**TOWN OF BAY HARBOR ISLANDS
DEVELOPMENT & REVIEW COMMITTEE MEETING
THURSDAY, OCTOBER 13, 2022**

**TOWN OF BAY HARBOR ISLANDS
COMMUNITY DEVELOPMENT
MEMORANDUM**

Subject: Site Development Plan Application – DRC Review #2
Proposed New Multiple-Family Development (44 DU)
Existing Bay Harbor Tower Site (30 DU)
10141-10143 East Bay Harbor Drive
Bay Harbor Islands Acct. No. SPR22-000024
MMPA Acct. No. 01-0702-1142

Date	09-29-2022	Sheet No.
Scale		A1.00
Project	0000

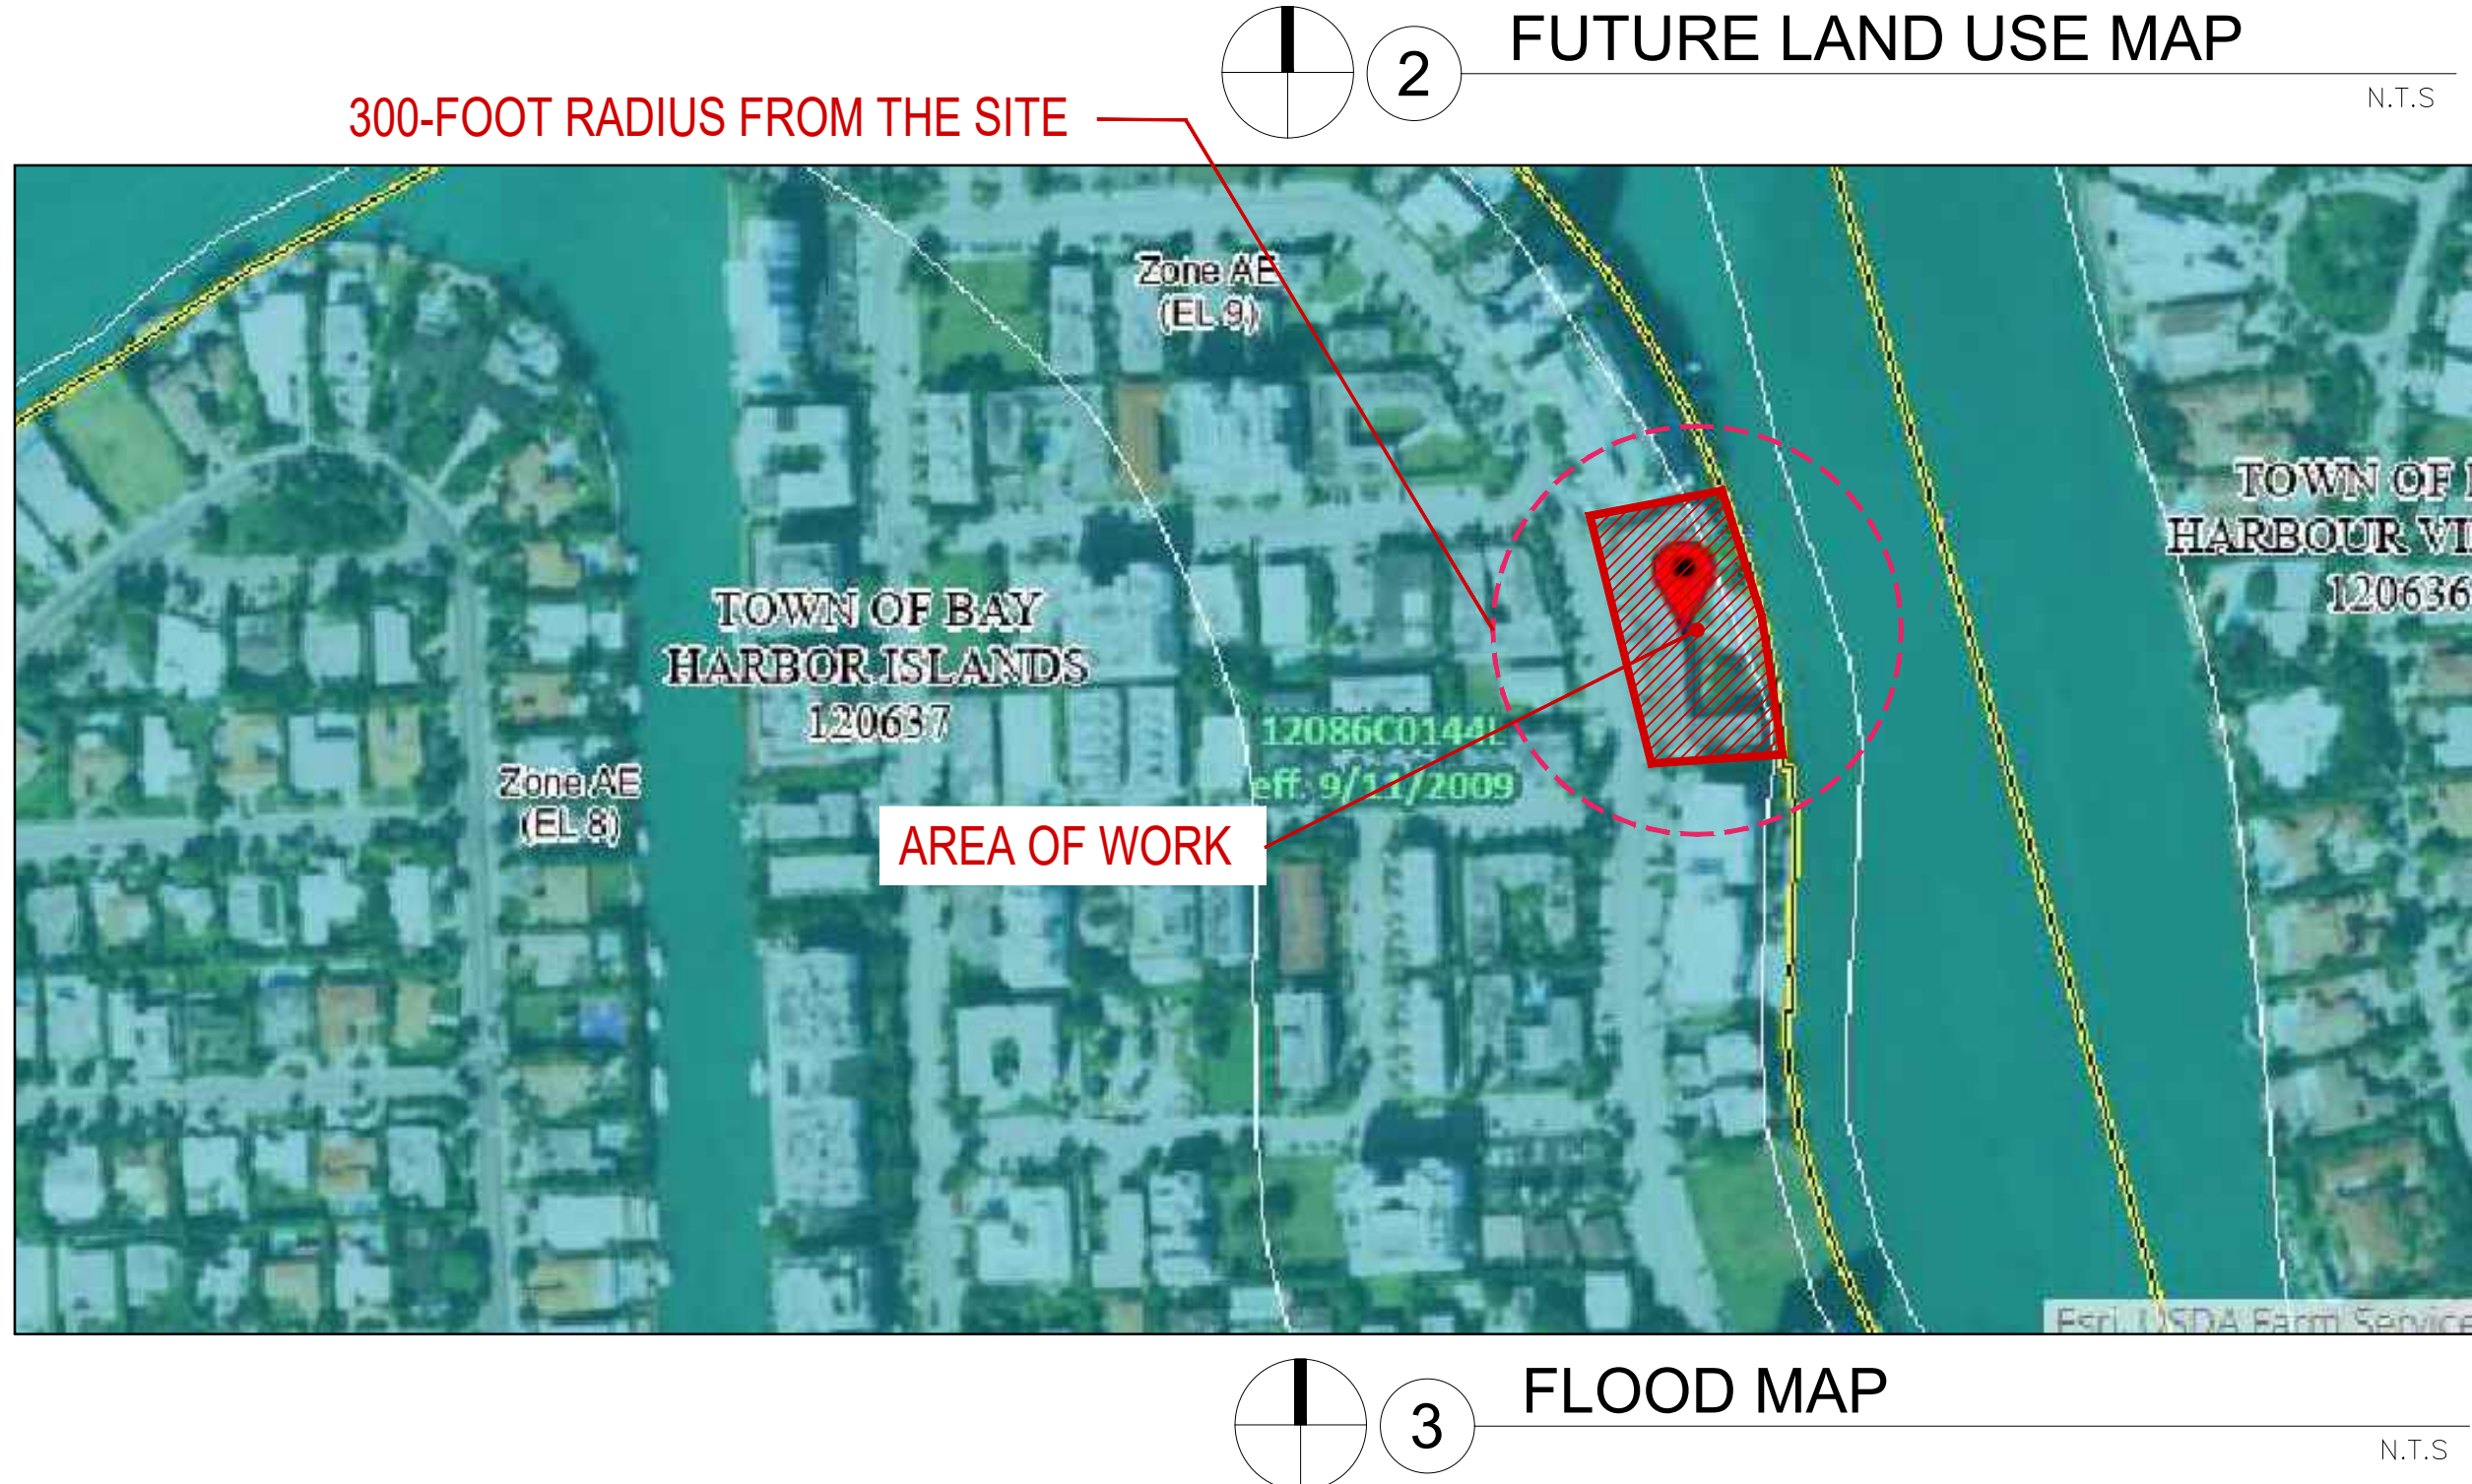
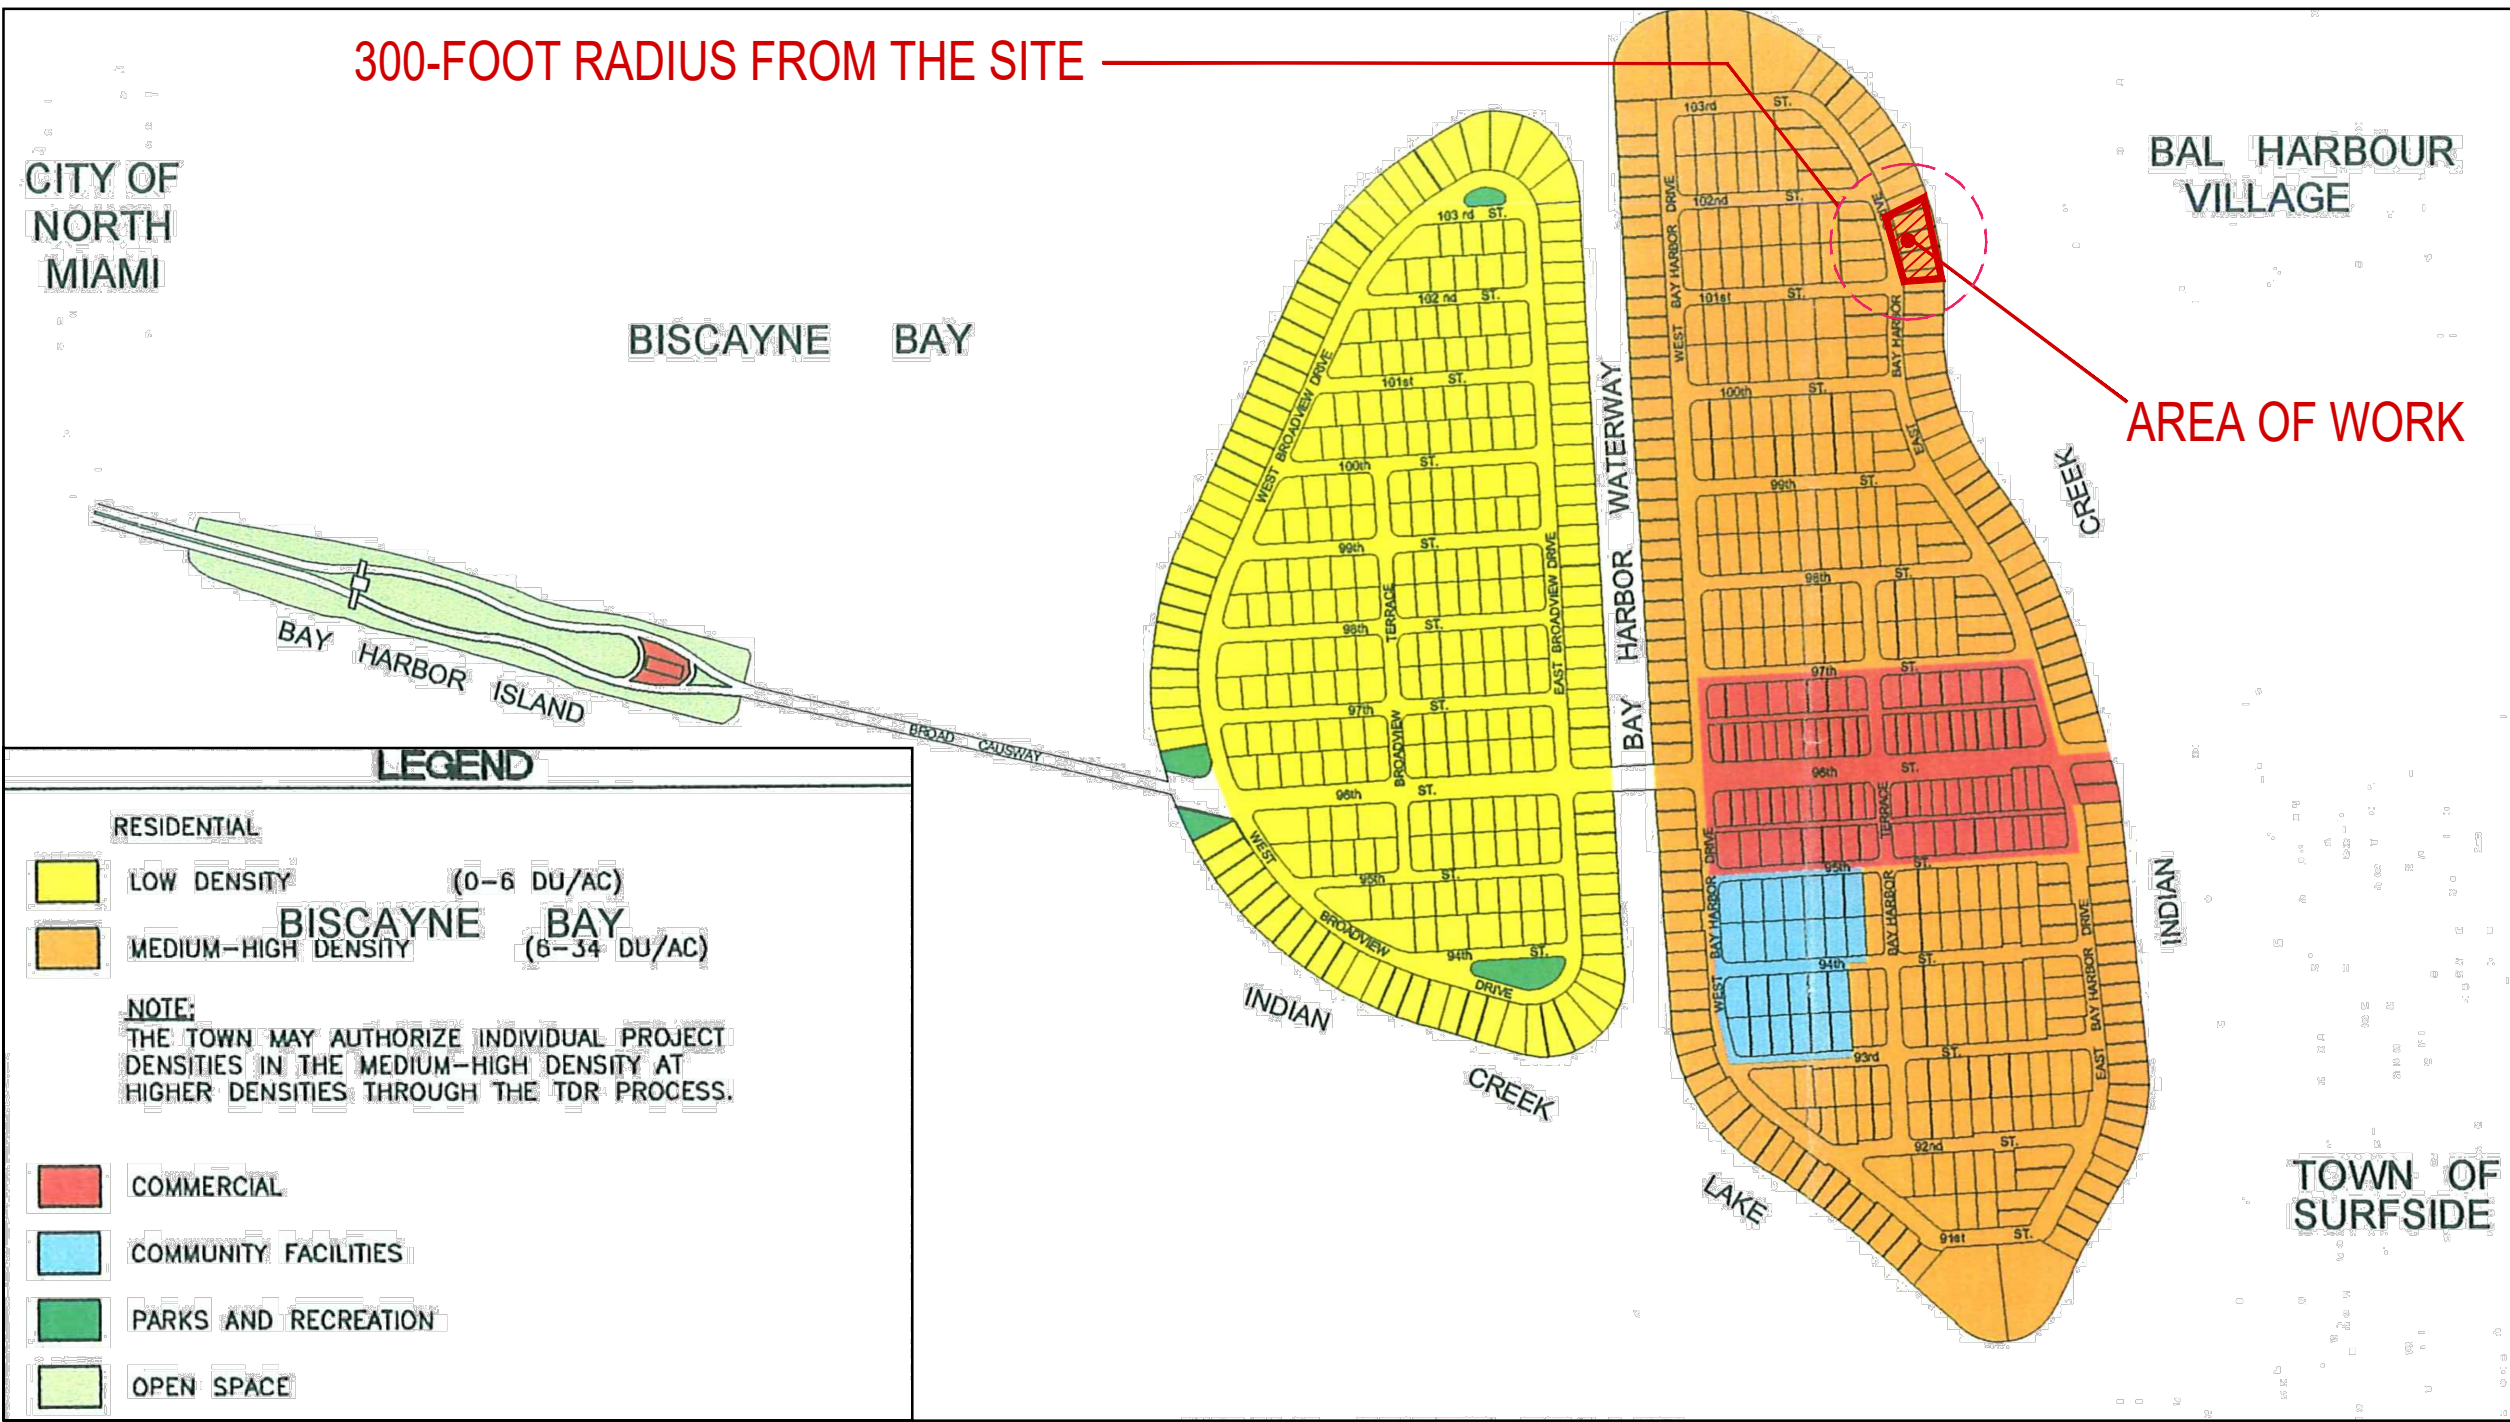
1. On Sheet A1.00 of the new plans in the Zoning Information / Site Data Table there is a breakdown of the proposed parking spaces by type. Based on our review this calculation data is correct. However, on Sheet A2.00 a similar parking breakdown calculation table does not match and is incorrect. Please revise the plans (Sheet A2.00) to present accurate information and be internally consistent.

PROJECT: 10143 East Bay Harbor Dr		 KOBİ KARP ARCHITECTURE INTERIOR DESIGN PLANNING	
MASTER PERMIT #:		REVISION DRC CITY COMMENTS 09/28/2022	
COMMENTS RESPONSES:		ELECTRICAL REVIEW - ERIC MERCED - 09/14/2021	
CONSULTANT			RESPONSES
ARCHITECTURE	1	On Sheet A1.00 in the Zoning Information Table the following issues are noted: >The table does not include a reference as to the required breezeway requirement or how this site complies. Only the building length calculations are provided. Please revise the plans to include the calculations. >As related to the proposed DU sizes there is no information provided as to the Code minimum DU size requirements nor proposed DU sizes demonstrating compliance. Please revise the plans to include this required information. >As related to the parking requirements, the plans state that 88 "standard" parking spaces are provided. A "standard" parking space is 8'-6" x 18' single vehicle side-byside per Sec. 23-30(a) with striping / car stops. As mentioned above the site plan includes a total of 88 parking spaces. Of the total 88 parking spaces provided, mechanical lifts are proposed for 16 spaces, 20 spaces are proposed for tandem parking spaces, drive-aisle valet parallel spaces are proposed for 15 spaces, and 37 traditional parking spaces are proposed. Revise the table to include this breakdown, even though it is listed on other sheets. Basic site information should be in one cohesive location for ease of review.	Table including breezeway requirements, information on DU and parking requirements has been added to sheet A1.00
